DOMINION NUCLEAR CONNECTICUT, INC.
MILLSTONE POWER STATION UNIT 2
CORE OPERATING LIMITS REPORT, CYCLE 19

CORE OPERATING LIMITS REPORT, CYCLE 19

TECHNICAL REQUIREMENTS MANUAL
APPENDIX 8.1
CORE OPERATING LIMITS REPORT, CYCLE 19

FIGURE 2.4-1
CEA Insertion Limit vs. THERMAL POWER With
Four Reactor Coolant Pumps Operating

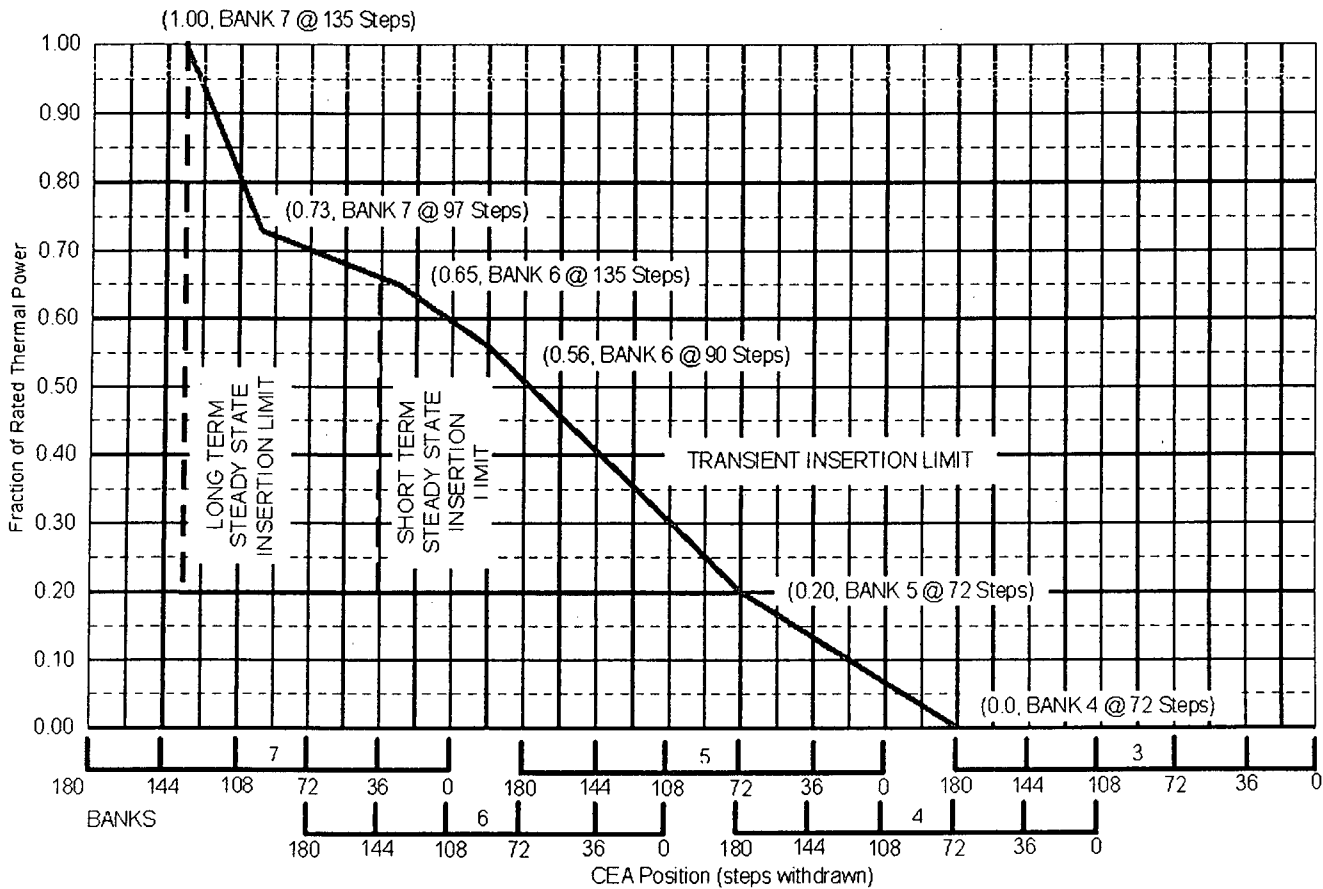
- Editorial change to correct a typographical error in Reference 3.11.
- Revision to page headers to reflect Cycle 19.
- Updated two references to reflect most current revisions.
- Addition of Reference 3.16 that was previously added to the MPS2 TSs.
- Addition of a footnote to Figure 2.4-1 for clarification purposes.

Note: Regulating CEAs that are ≥ 176 steps withdrawn are considered fully withdrawn and are acceptable per this figure.
